PLANNING & ZONING AGENDA ITEM #7

SUBJECT: Approval of a Site Plan for Boulder Pointe Townhomes

COMMENT RESPONSE LETTER

BOULDER POINTE SITE PLAN

BOULDER POINTE DIMENSION PLAN

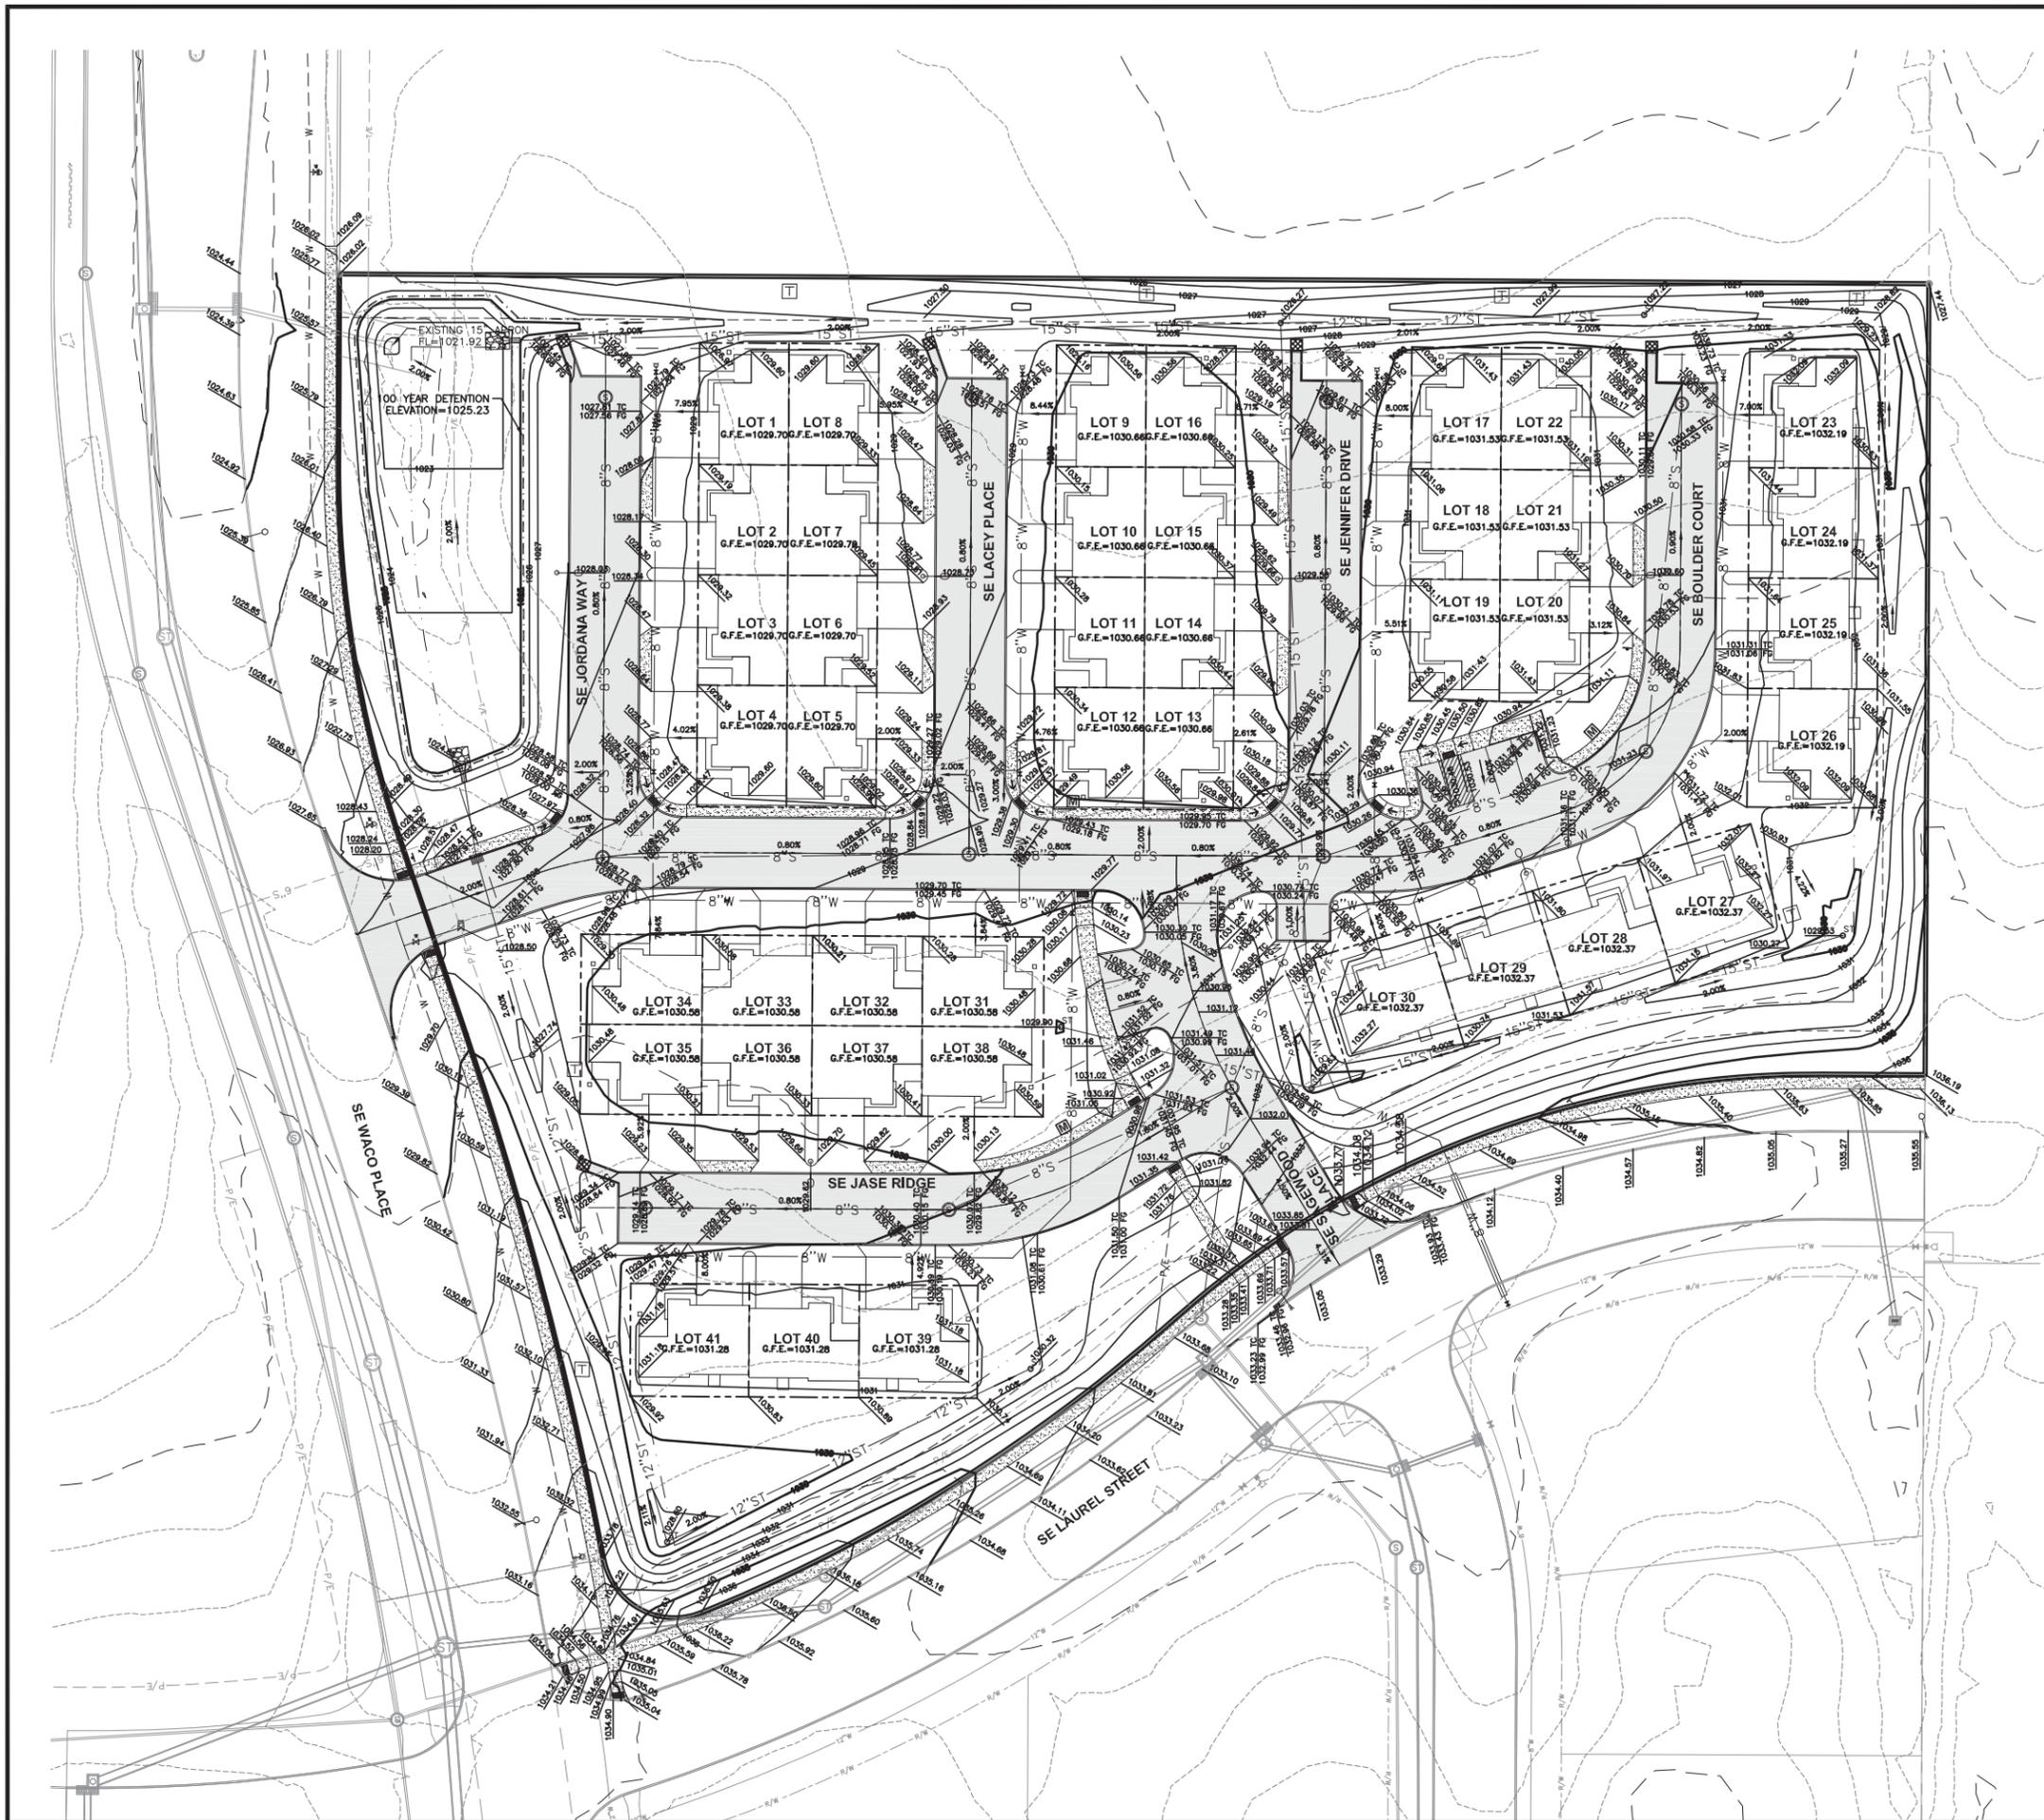
26. ~~Names should be provided for all proposed private streets.~~ The prefix of 'SE' should be added to all internal private streets. Additionally, staff would request that Indi Ridge be renamed as there is an existing street named SE Indigo Ridge in Waukee which may cause confusion.

- **The street names have been modified.**
31. ~~All sidewalk crossings with private streets should be provided with truncated domes and warning panels.~~ All private sidewalks needed from the individual driveways to the front doors of each unit should be indicated on the site plan.

- **The sidewalks have been shown.**
36. ~~All proposed patios related to the single loaded buildings should be indicated on the plan set for clarity.~~ The stoops on the rear side of the units should also be indicated on the plan set.

- **All of the stoops have been shown.**
38. ~~The location of a monument sign(s) should be indicated on the site plan meeting the 15 foot setback requirement from all property lines.~~ A note should be added to the plan set indicating

any future monument sign(s) to be reviewed and approved by the Development Services Department.

41. General Note #17 should be eliminated from the plan set.

- **This note has been added to the general notes as No. 19.**

- **The note has been deleted.**

**BOULDER POINTE
 GRADING PLAN**

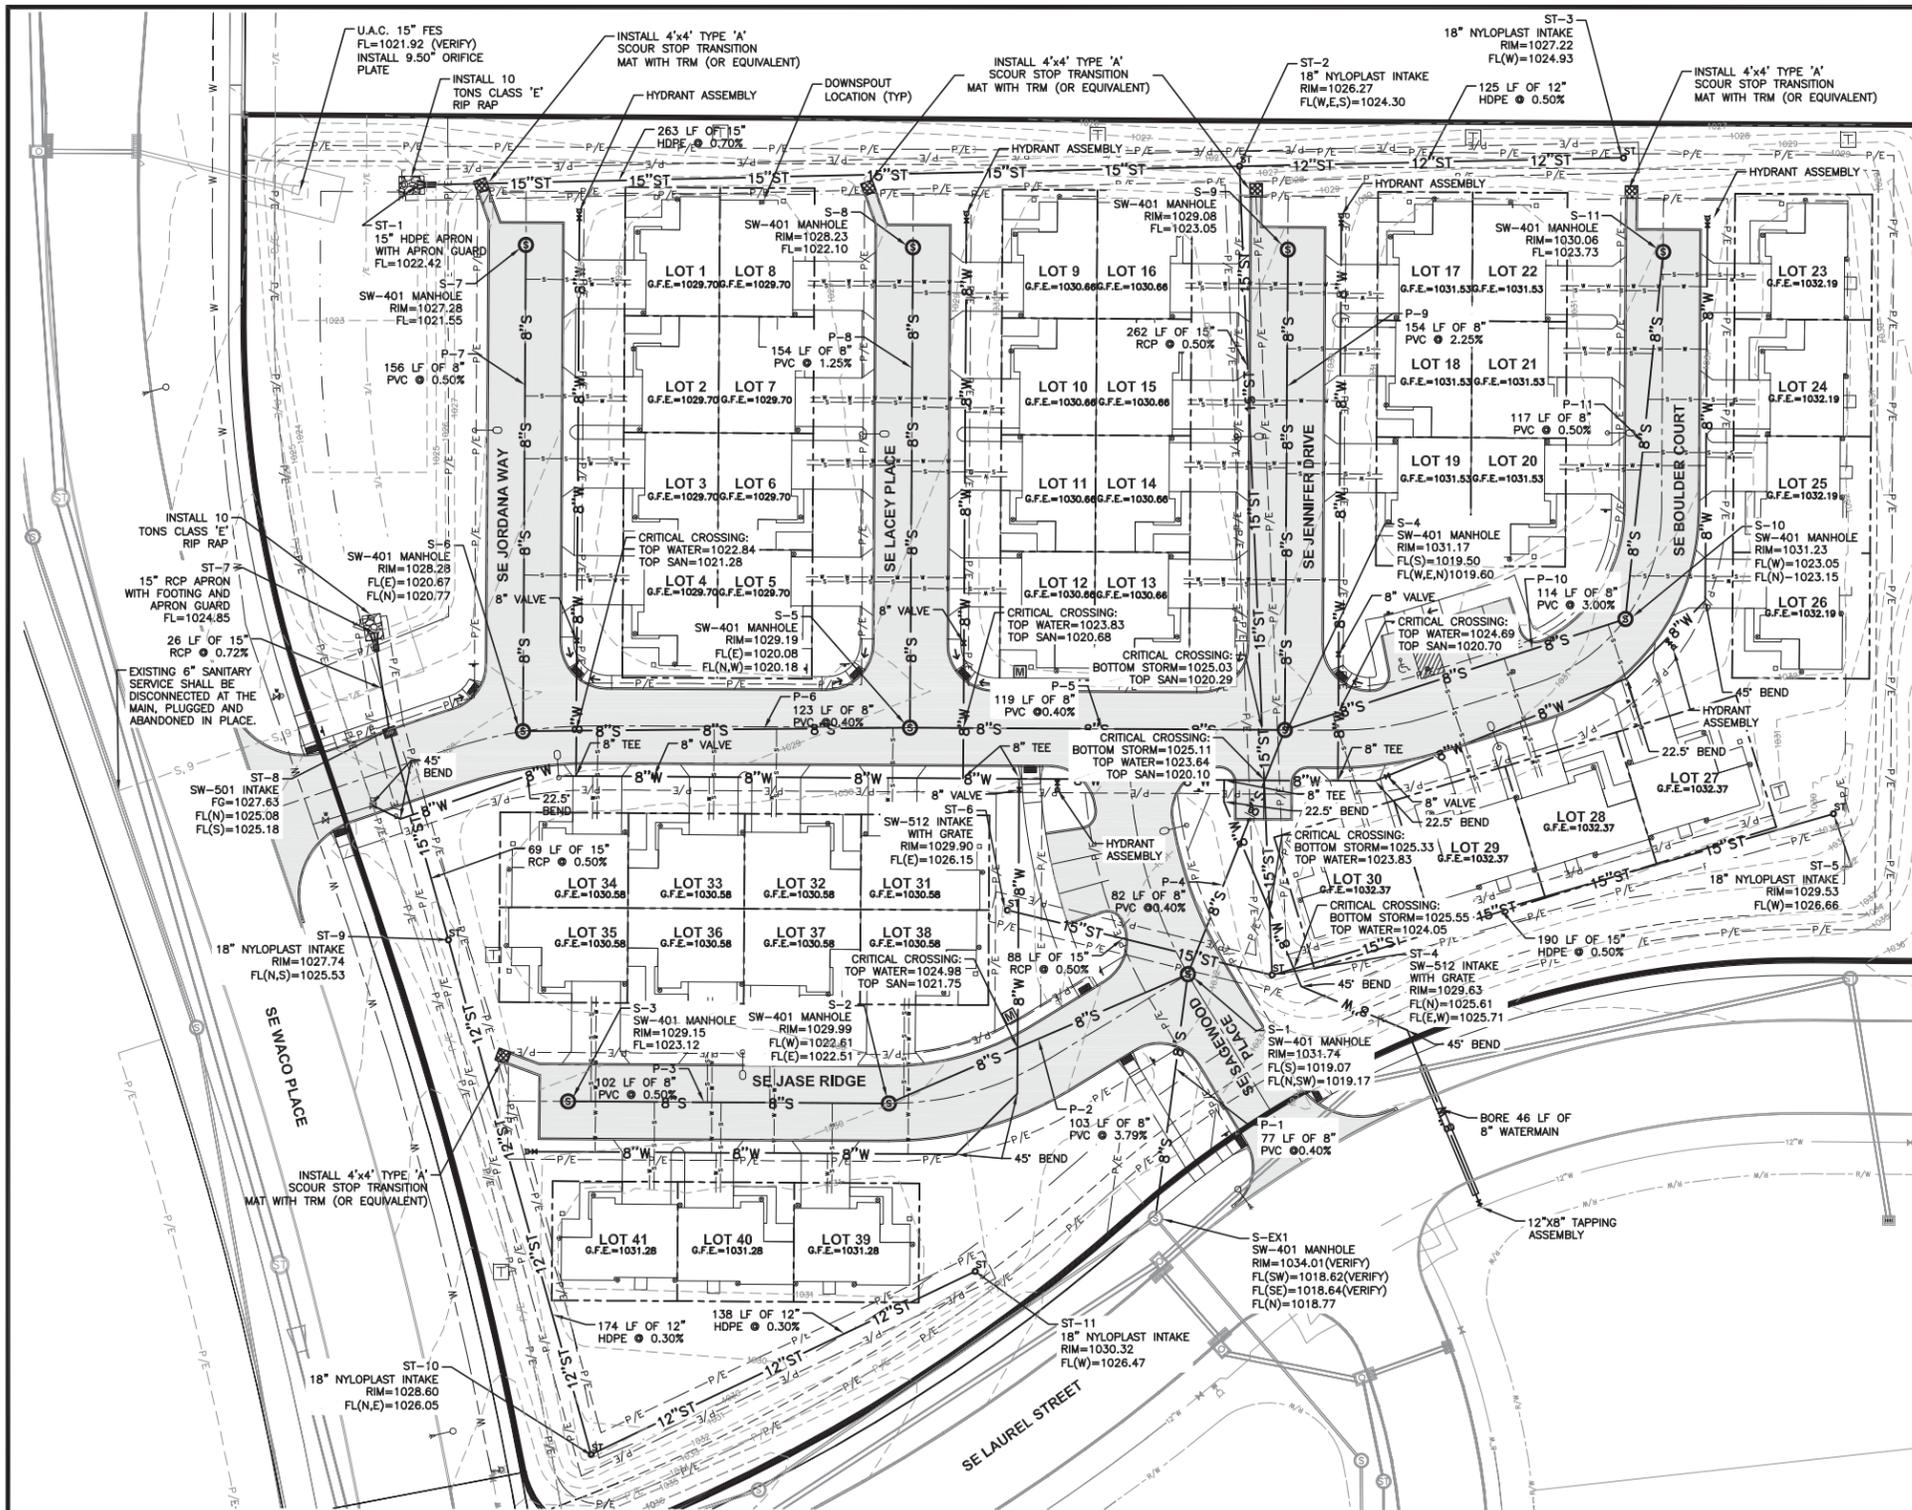
44. ~~Spot elevations should be provided at all outlet and inlet locations including the larger detention area in the northwest corner of the site.~~ The existing elevation of the flared end section at the outlet of the detention pond in the northwest corner of the site should be indicated on the site plan for clarity.

46. Downspout locations should be identified on the site plan. ~~Staff would request that all downspouts be tied directly into the proposed private storm sewer. Please address.~~

- **The existing elevation has been labeled.**

- **The downspouts have been shown with a symbol on page 5 of the site plan.**

PROJECT: **Willia s Pointe Plat 11 - Lot 1**
EIGHT PLEX
 Waukee, IA

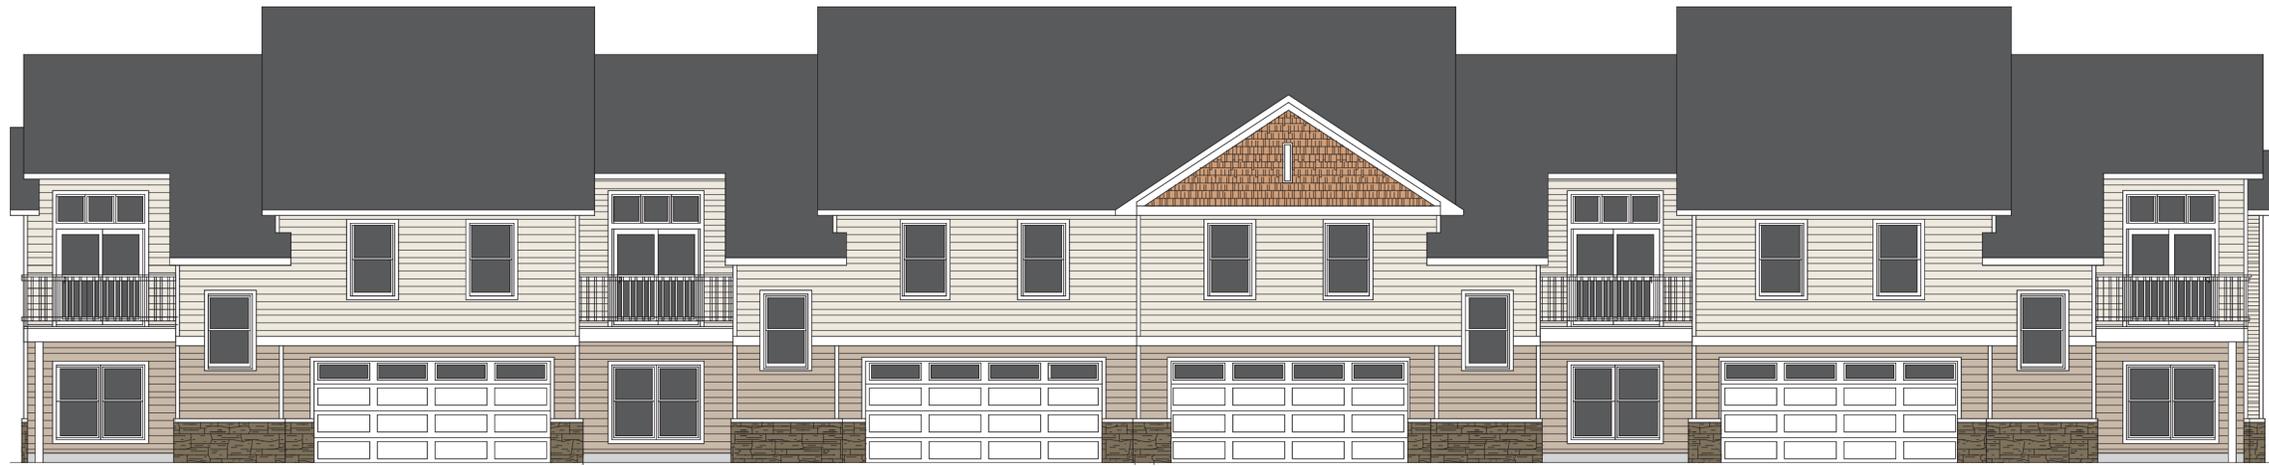
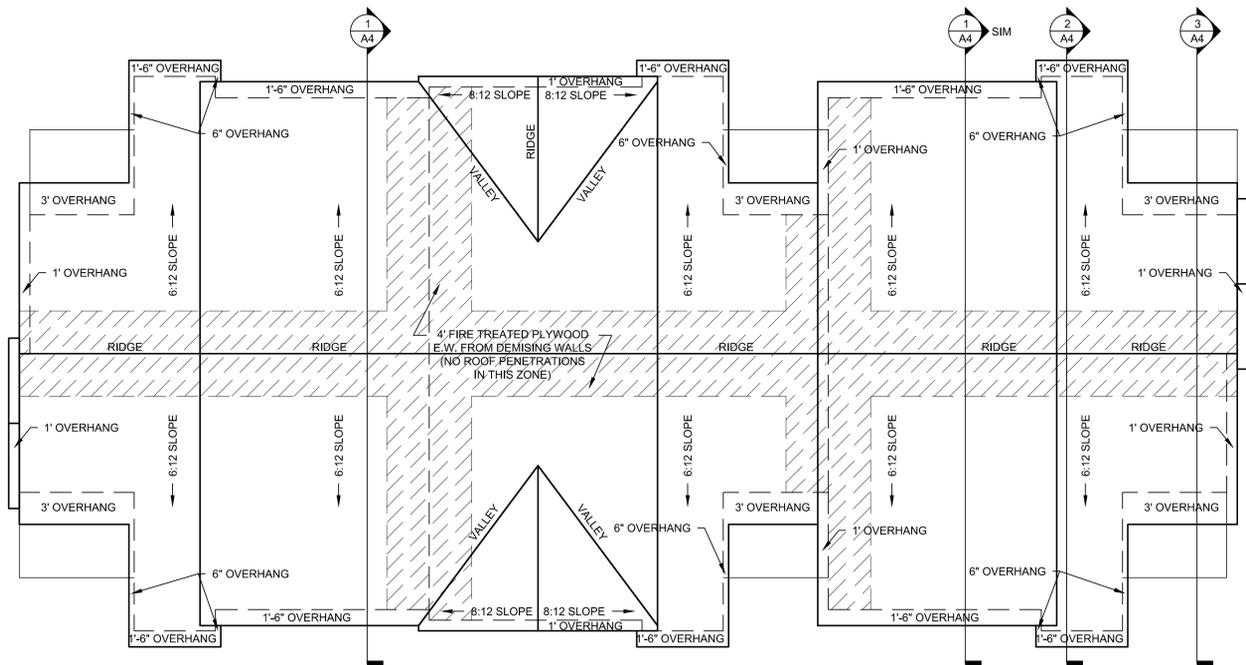
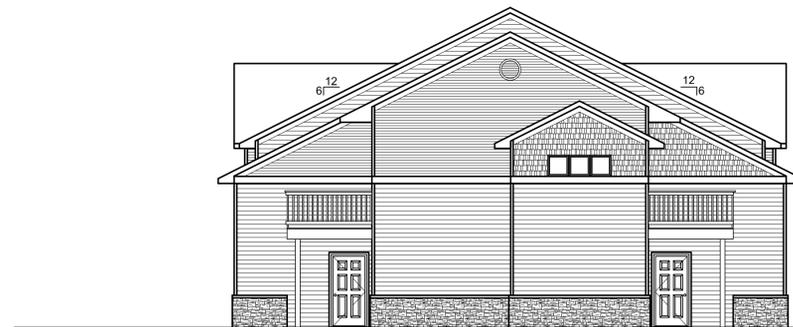
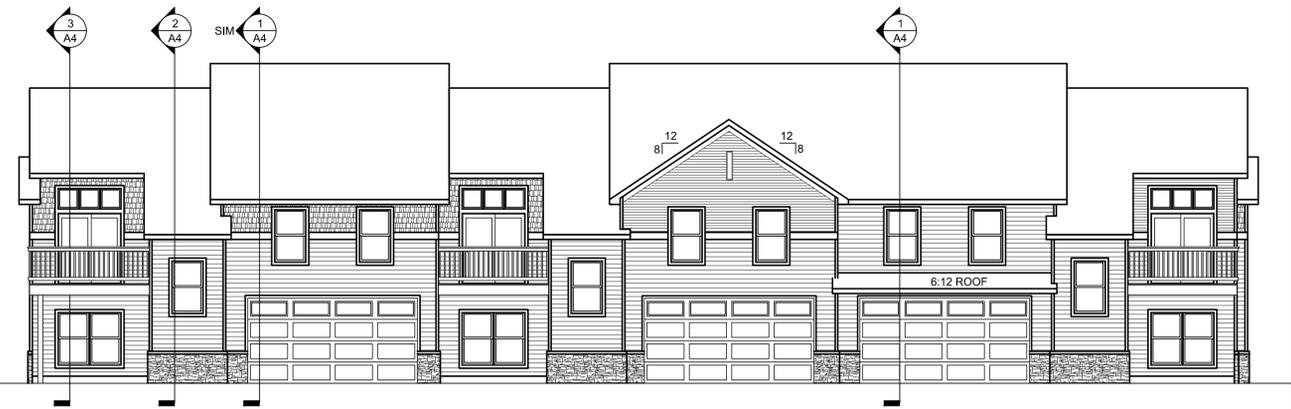
73. ~~As noted during the review of the PD Amendment (rezoning) the current rear elevations of the single loaded units do not meet the intent of the site plan ordinance for providing the same level of architecture on all side of the building. Additionally, each elevation is required to incorporate the use of brick or stone; which is not being met. Furthermore, the rear elevations do not address the visual splitting of the building into a maximum 20 foot linear section under the provided terms of meeting the ordinance requirements. Staff would recommend reviewing~~

~~Section 304.6B(3) of the Site & Building Development Standards Ordinance in addition to Pages 4 & 5 of the Architectural Design Example Book.~~ The single loaded unit elevations should be provided in color.

- **The building elevations have been provided.**
